Access Compliance Report

Public Rights-of-Way

| Intersection ID: 10019902 | Main Street: ARCO_CORPORATE_DR | Cross Street: N/A | Location: NW |
| ADA ID: 1226EC870430 | Ramp Type: Directional1 | Initial Pass/Fail: Fail | Overall Compliance: No |

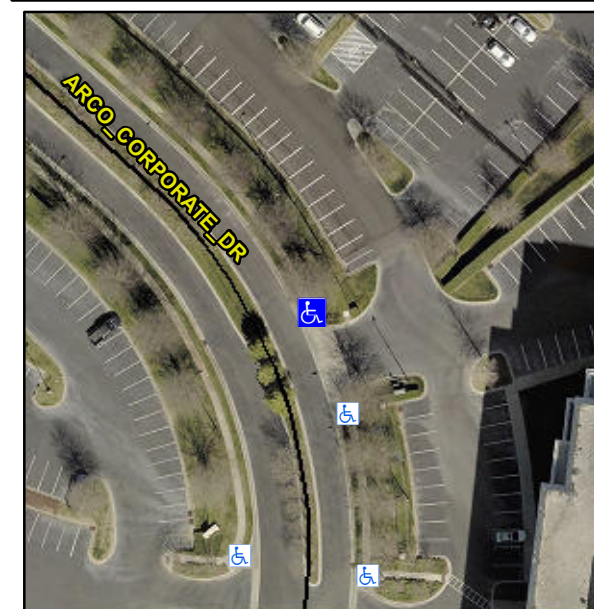
R304.2.2, R304.5.3

| Compliance | Description | Data | Compliance | Description | Data |
|------------|-----------------------|-------|------------|-----------------------------|------|
| No | Ramp Slope (%) | 8.7 | N/A | Grade Break XSlope (%) | 0.0 |
| No | Ramp XSlope (%) | 5.4 | | | |

Remove & Replace Entire Ramp.
